Dispersion of aqueous effluent from Hunterston power stations Annex – Additional Scenarios

Reference: ENE – 0328A/R2

To: [REDACTED]
EDF Energy Nuclear Generation Ltd
Hunterston B Power Station

This report is an annex to the main report *Dispersion of aqueous effluent from Hunterston power stations*, which discusses the impact of removal of main cooling water flow and changing the discharge location. Building on the executive summary of the main report, this annex responds to queries from the Scottish Environment Protection Agency (SEPA) following a consultation about the proposed alternative discharge arrangements.

Figure 1 – Activity concentration of H-3 in unfiltered seawater in the swimmer dilution volume for alternative discharge arrangements to the bank (Scenario 7)

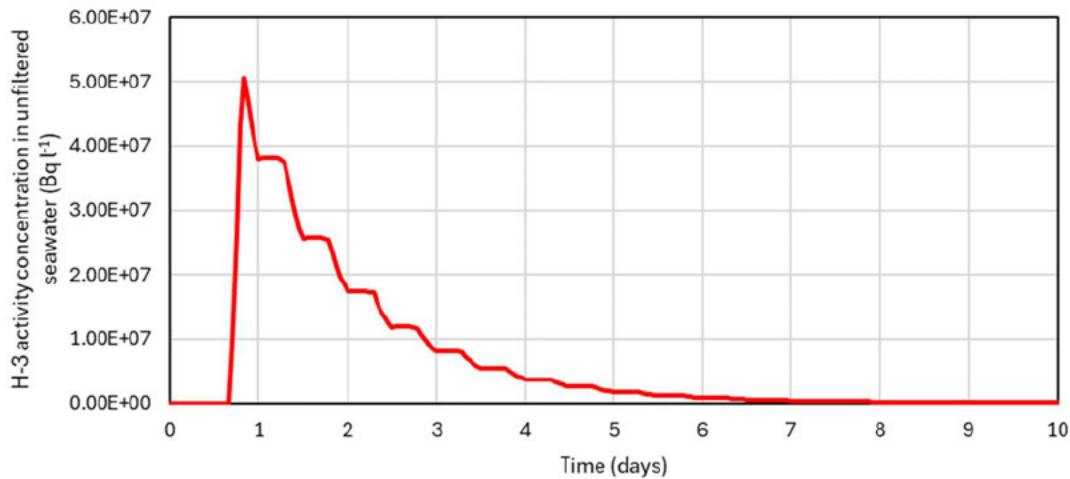
An additional scenario was requested for Hunterston A and Hunterston B permit limit discharges to the bank compartment, centred around low tide. The results for this scenario were used to inform a dose assessment for an open water swimmer.

Table 9 shows the maximum activity concentrations in unfiltered seawater scaled to the swimmer dilution volume. The Model Dilution Volume for East of Cumbrae compartment is 9.45 10⁶ m³ and the Swimmer Dilution Volume is 12,500 m³ (based on the SEPA definition of 50 m wide × 50 m long × 5 m deep). We applied a Swimmer Scaling Factor of 756 to the modelling results. Maximum values refer directly to the values presented in Table 8.

Figure 1 shows the variation of the activity concentration of H-3 in unfiltered seawater in the dilution volume occupied by the swimmer compartment over the first 10 days. The peak value is reached shortly after the discharge.
